SOUTH EUNICE UNIT

SUNDRY NOTICES AND REPORTS ON WELLS
(DO NOT USE THIS FORM FOR PROPOSALS TO DRILL OR TO DEEPEN OR PLUG BACK TO A
DIFFERENT RESERVOIR. USE "APPLICATION FOR PERMIT" (FORM C-101) FOR SUCH
PROPOSALS.)

54

PERFORM REMEDIAL WORK ☐ PLUG AND ABANDON ☒TEMPORARILY ABANDON ☐ CHANGE PLANS ☐PULL OR ALTER CASING ☐ MULTIPLE COMPLETION ☐OTHER: ☐

CURRENT WELLBORE

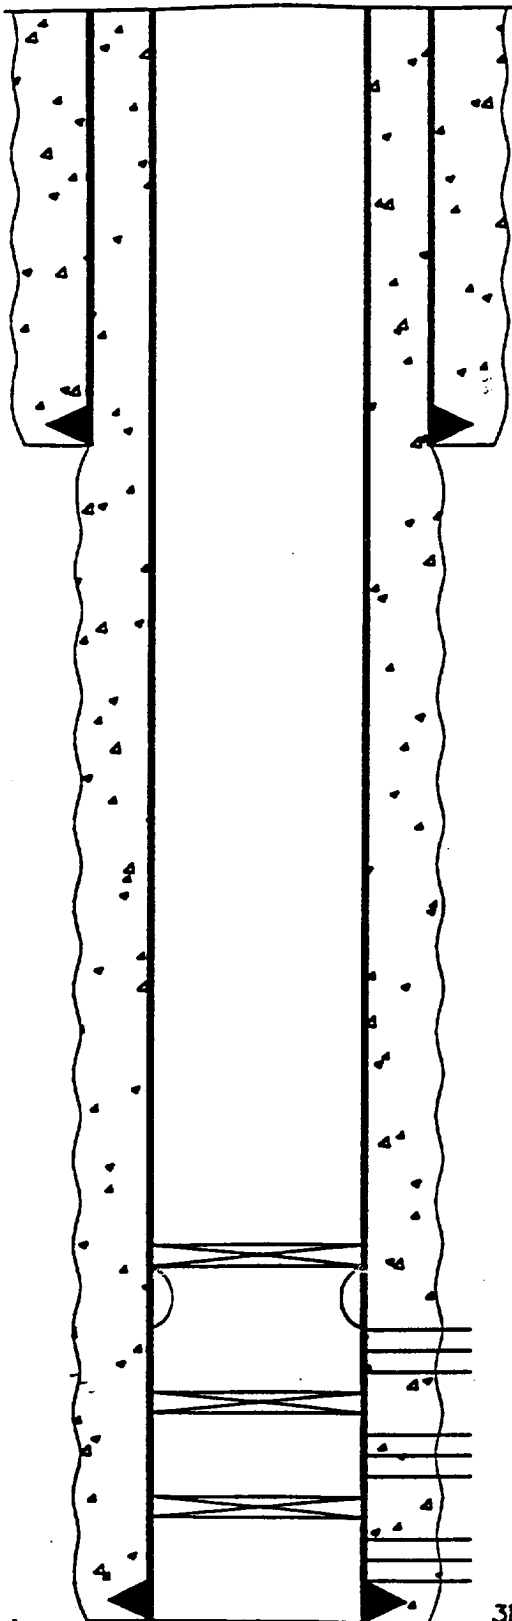
SPOT 25SX
CEMENT PLUG 1 B.O.S.
F/3048-2948 TAG
THE COMMISSION MUST BE NOTIFIED 24
HOURS PRIOR TO THE BEGINNING OF
PLUGGING OPERATIONS FOR THE C-103
TO BE APPROVED.
